**Marion County
Board of County Commissioners**

**PLANNING & ZONING SECTION
STAFF REPORT**

P&Z Date: 04/28/2025	BCC Date: 05/20/2025
Case Number	250509ZP	
CDP-AR	32534	
Type of Case	PUD Amendment: Request to 1) add one parcel to PUD; and 2) modify ingress and egress.	
Owner	CORTA Ocala, LLC	
Applicant	N/A	
Street Address/Site Location	8410,8422,8424,8426,8428,8430,8440 SW HWY 200, Ocala FL 34481	
Parcel Number(s)	15 parcels of existing PUD including 3501-200-018, 019, 020, 021, 022, 023, 034, 035, 036, 037, 038, 039 & 040; 3501-400-003 & 004 One (1) added parcel to PUD: 3501-400-002	
Property Size	±9.22 acres	
Future Land Use	Commercial (COM)	
Existing Zoning Classification	Planned Unit Development (PUD) & Community Business (B-2)	
Overlays Zones/Special Areas	Secondary Springs Protection Zone	
Staff Recommendation	Approval with conditions	
P&Z Recommendation	Approval with conditions (6-0)	
Project Planner	Xinyi Cindy Chen	
Related Cases	CORTA PUD: 240506ZP B-2 to PUD – Approved (Concept Plan 05/2024 & Site Plan 08/2024)

Figure 1 – Proposed Amended Corta Commons PUD Site Plan

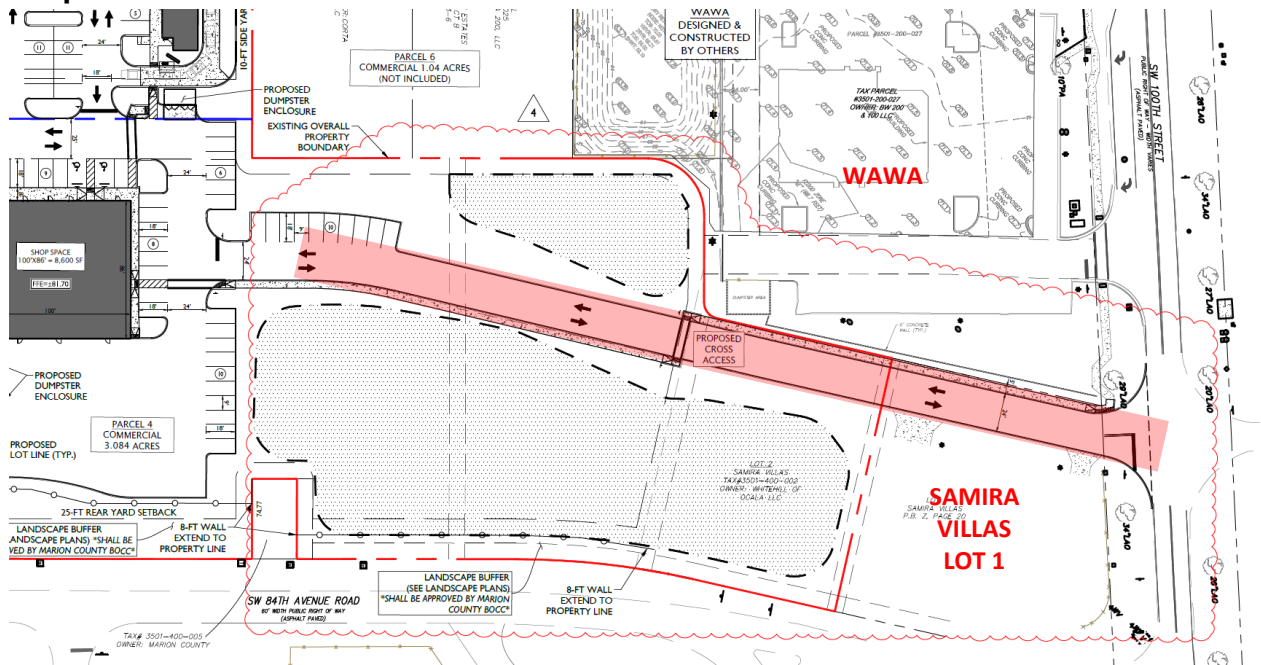
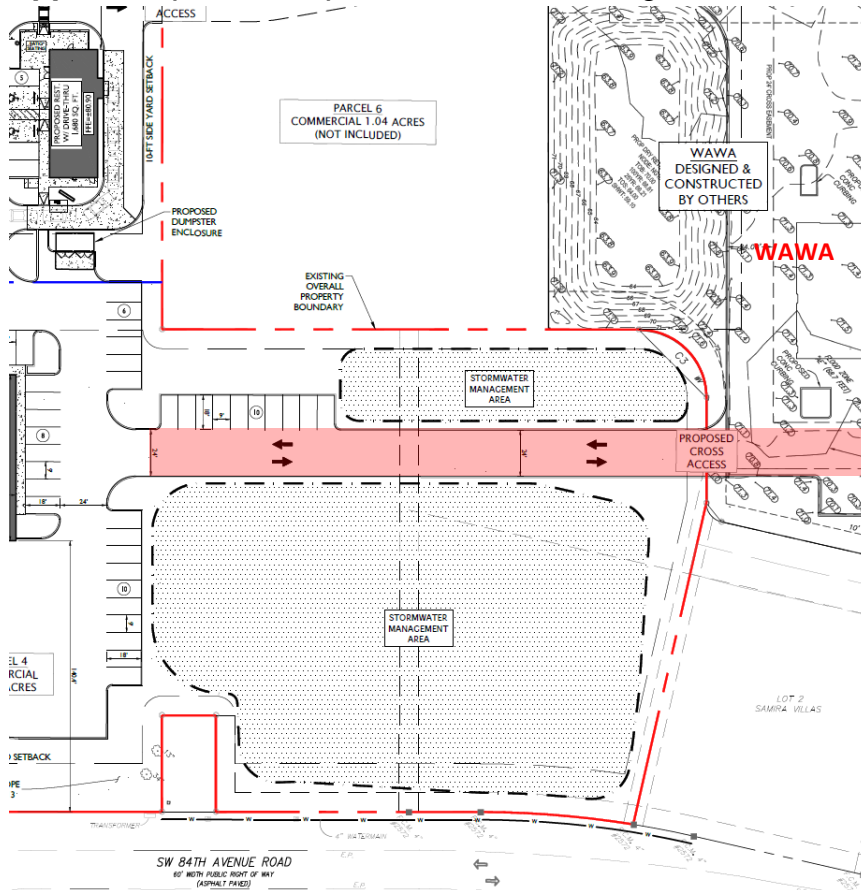
The applicant proposes to add one 0.48-acre parcel 3501-400-002 to the PUD development (see red box in Figure 3). The added parcel has been purchased and owned by the applicant/developer CORTA Ocala LLC. The added parcel is located on the east side of existing PUD and adjacent to the existing PUD. The use of this additional parcel is proposed to be used as an extension to approved DRA and an easement for proposed driveway relocation from PUD commercial area to SW 100th St.

The applicant proposes to modify the approved ingress and egress at SW 100th St by eliminating cross access through Wawa's property to SW 100th St and relocating it through the newly added parcel within PUD and an adjacent property Samira Villas Lot 1 (PID 3501-400-001). The adjacent property, located at the corner of SW 100th St and SW 84th Ave Rd, is zoned B-2 (Community Business) with a Commercial land use designation and is currently used as a residential rental. This modification is requested due to unsuccessful negotiations between the applicant/developer and Wawa regarding cross-access for the Corta Commons development. At the time of this staff report's publication, the applicant has not reached an agreement with the owner of Samira Villas Lot 1 regarding the cross access easement for commercial and construction use.

- **Request #2:**
Removal of approved access through the rear side of Wawa is acceptable. The Traffic Study (Attachment F) was conducted using a conservative approach, assuming that cross-access through the rear side of Wawa would not be permitted due to challenges in securing an agreement with Wawa at that time. The Traffic Study was approved based on this assumption that access through Wawa would not be available. Thus, despite the eventual lack of cross-access agreement from Wawa, the remainder of approved access remains adequate to meet the development's needs.

However, Growth Services does not support the proposed additional ingress and egress through Samira Villas Lot 1 due to code noncompliance and its significant impact on the residential property at the corner parcel. First, per LDC Sec. 4.1.4.O, *"Use of residentially zoned property for access. No land which is residentially zoned shall be used for driveway, walkway, or access purposes to any land which is zoned for commercial, industrial, or institutional use."* While the corner parcel is zoned B-2, its current use is residential. The introduction of commercial traffic is disruptive to residents and the surrounding community. Second, as of the time of this report, the applicant has not provided documentation confirming an agreement with the owner of the corner residential parcel regarding the access easement. Without the adjacent owner's consent, the use of the proposed cross access remains uncertain. According to the LDC, change of approved external access of PUD is subject to the approval of the Board. Its approval could prompt further dialogue with the adjacent owner to facilitate the project moving forward but may also rise challenges from the property's

Therefore, staff does not support the proposed addition of ingress and egress to SW 100th St through residential-use Samira Villas Lot 1 but supports the removal of approved access through the rear side of Wawa. Staff recommends that the ingress/egress to be maintained in accordance with the conditions of the previously approved PUD from case #240506ZP with the removal of the approved access through the rear side of Wawa.

1. The PUD is restricted to a total of 30 dwellings units multifamily and **7.59-acre** commercial uses consistent with the Marion County Land Development Code, the PUD Application, **PUD Site Plan (dated 03/27/2025; Attachment B), and following conditions.**

- E. **Buffers between the added parcel #3501-400-002 and adjacent residential use parcel 3501-400-001 shall be provided per LDC requirement,**
 - ~~E. F.~~ Buffer types and illustrations shall be submitted with the site plan phase for approval.

22. Prior to completion and approval of the Site Plan, a cross access easement reflecting the revised use and configuration of the cross-access through Parcel 3501-400-001 shall be submitted and approved to the satisfaction of the County Engineer and Growth Services director, in a form acceptable to the County Office of Engineer. The easement shall be signed by all affected property owners.

23. The cross-access driveway connecting the approved PUD development site to SW 100th St shall be designed and constructed in accordance with County standards and as approved by the County Engineer.
